# SERVICE BULLETIN

**BULLETIN NUMBER:** 259

**SUBJECT:** Drive Belt Tension

3.0 BPMG-612

## ADJUSTING THE DRIVE BELT

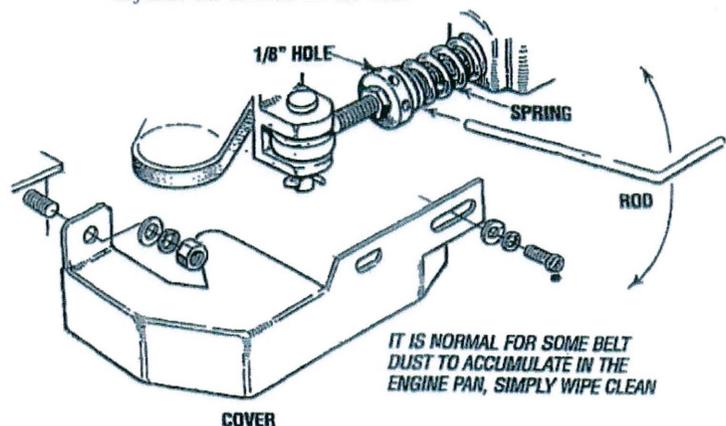
**DETAIL:** The generator drive belt tension specification as shown/illustrated in the Operator's Manual publication #048009 is in error. It does not coincide with our engineering design and the actual adjustment being set by our manufacturing department. The adjustment specification of 1-1/4 inches (31.79mm) should be 1-1/8 inches (28.57mm).

Please correct the specification found in Operator's Manuals currently in the field along with inserting a copy of this bulletin. Manual part number 48009 page 18 of additions 1 and 2 and page 22 of editions 3 and 4.

To set the spring tension at 1 1/8", release the jam nut and use a rod such as an allen wrench to turn the adjusting nut (as shown) to tighten or loosen the spring tension, which in turn adjusts the tension on the belt.
